## Application for Licence Amendment

<b>Licence Number</b>	L8593/2011/1
<b>Licence Holder</b>	Golden Grove Operations Pty Ltd
<b>ACN</b>	114 868 325
<b>File Number</b>	2011/007842-1
<b>Premises</b>	Scuddles & Gossan Hill Mine YALGOO WA 6635  Legal description –  Part of Mining Tenements: M59/3, M59/90, M59/195, M59/227, M59/361, M59/362, G59/19-23, G59/24, L59/22, L59/26 and L59/41  As defined by the Premises maps attached to the Revised Licence
<b>Date of Report</b>	4 May 2023
<b>Decision</b>	Revised licence granted

**Figure 2: Coffer Dam 2 embankment section**

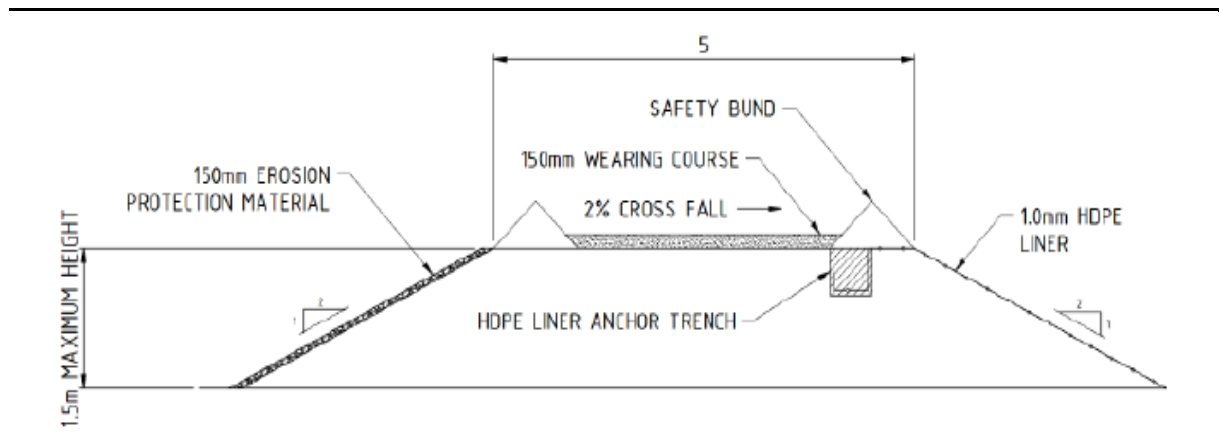
The Coffer Dam 2 has been designed with a maximum embankment height of 1.5 m and a crest width of 5 m. The dam will be lined with a 1.0 mm HDPE liner which is anchored within a trench at the crest (Figure 2).
